Response to Reviewer #2

We sincerely thank Reviewer #2 for their thoughtful and constructive feedback on our manuscript *Development of a wind-based storm surge model for the German Bight*. The comments contributed to improve the manuscript's clarity and quality. Below, we provide a detailed point-by-point response to the concerns raised and explain how we plan to incorporate the suggestions into the revised version.

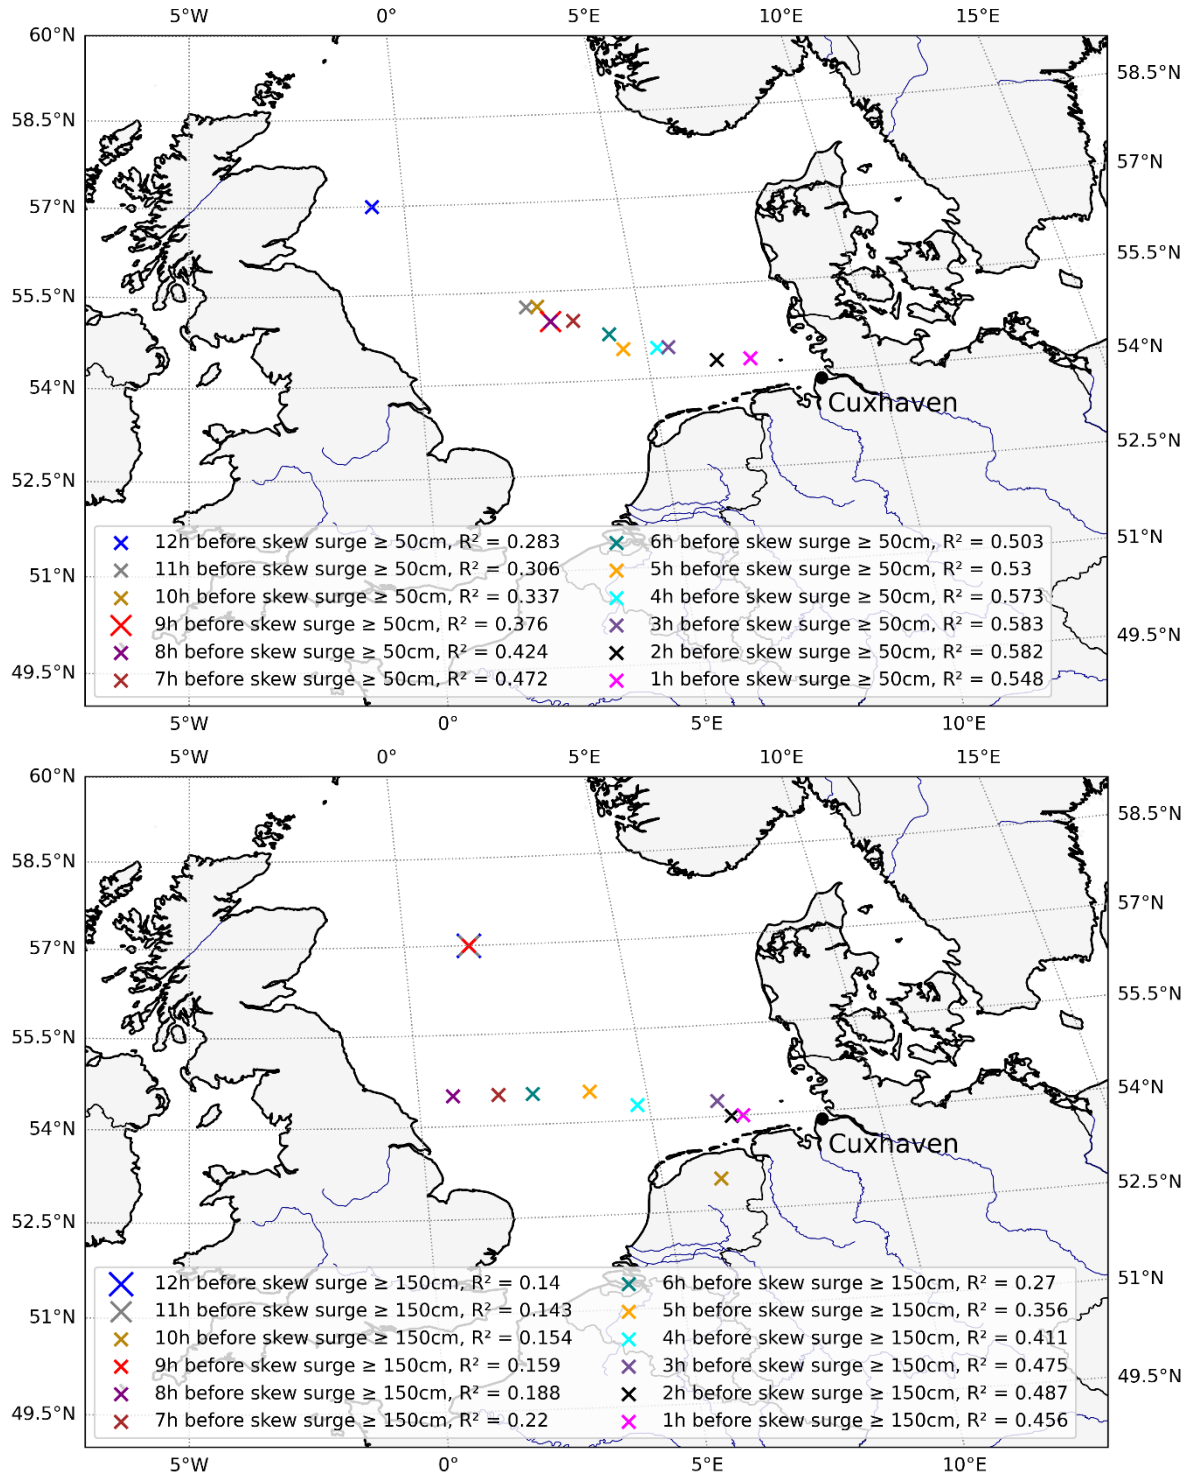
Figure 3: would it be possible to show the same for both $hwss \geq 50$ and $hwss \geq 150\text{cm}$?

Response: We thank the reviewer for the suggestion to include additional plots for both $hwss \geq 50\text{cm}$ and $hwss \geq 150\text{cm}$ in Figure 3. While we understand the interest, we believe adding these plots would not provide significant added value to the manuscript, as for the final storm surge model we use $hwss \geq 80\text{cm}$. For your information, we have included the requested figures below to provide additional context (Fig. R1).

The path of grid cells with a training threshold of $hwss \geq 50$ cm is similar to that for $hwss \geq 80$ cm, both following a northwest to southeast orientation (Fig. R1, upper plot). In contrast, the path of grid cells with a training threshold of $hwss \geq 150$ cm shows no clear or consistent pattern, primarily due to the significantly lower amount of available data (Fig. R1, lower plot). Additionally, this path does not make sense in terms of the physical processes driving storm surges, further highlighting the limitations of using such a high threshold for training.

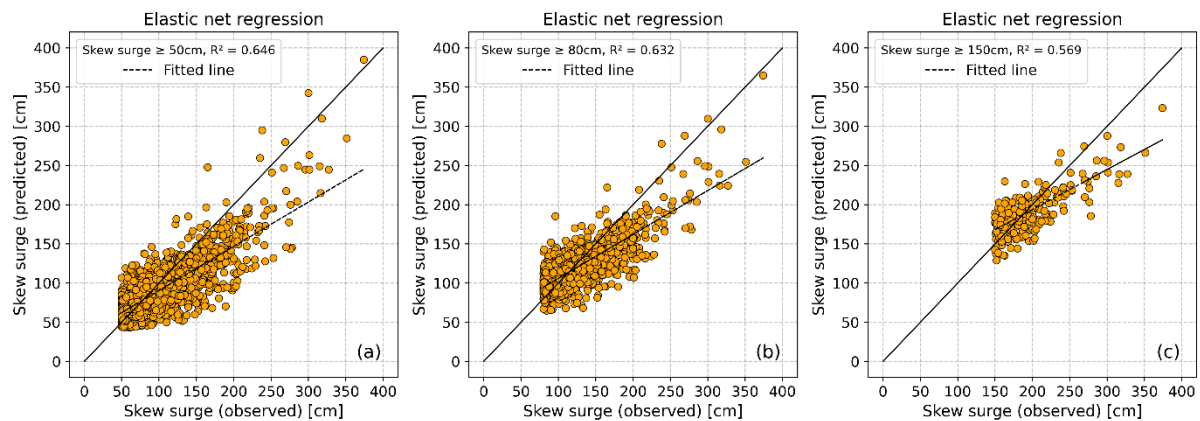
Line 305: Referring to my comment 3 above, you could use 50 cm as the threshold as well, correct? From Figure 5, it’s difficult to determine whether 50 cm is better than 80 cm. However, if you opt for 50 cm, would bias correction still be necessary?

Figure 5: please show the chosen method (elastic net) but instead show a similar plot for both $hwss \geq 50$ and $hwss \geq 150$. Please also include the fitted line for the data.

Response: We thank the reviewer for the thoughtful suggestions regarding Figure 5. The purpose of this figure is to illustrate the differences among the three regularization methods rather than to compare thresholds. The differences between thresholds, including $hwss \geq 50$ cm and $hwss \geq 150$ cm, are already shown in Figure 4. While we believe adding plots similar to figure 5 but for $hwss \geq 50$ cm and $hwss \geq 150$ cm does not significantly enhance the manuscript, we include these figures here for your reference (Fig. R2).

The good correlation of the model trained with a 50 cm threshold is primarily driven by lower values and higher surges are still underestimated. When comparing the model outputs trained with thresholds of 50 cm (Fig. R2 a) and 80 cm (Fig. R2 b), the visual spread of points in the range of 200 cm to 350 cm (observed values) is smaller when using the 80 cm threshold. Again, the choice of 80 cm as the training threshold is subjective and represents a balance between data availability, high threshold and model performance (lines 302-307).

With a training threshold of $hws \geq 150$ cm (Fig. R2 c), the model has too few data points to train effectively. Additionally, the location and time lag of the predictors identified for this threshold do not make sense in terms of the physical processes driving storm surges. Furthermore, using this threshold does not significantly enhance the prediction of high surge values, making it less useful.

Although we understand the idea of including fitted lines in Figure 5, we have decided not to include them in the manuscript. While these lines illustrate the correlation especially for lower values, the focus of the figure is on high surge values, which are more relevant to the manuscript's objectives.
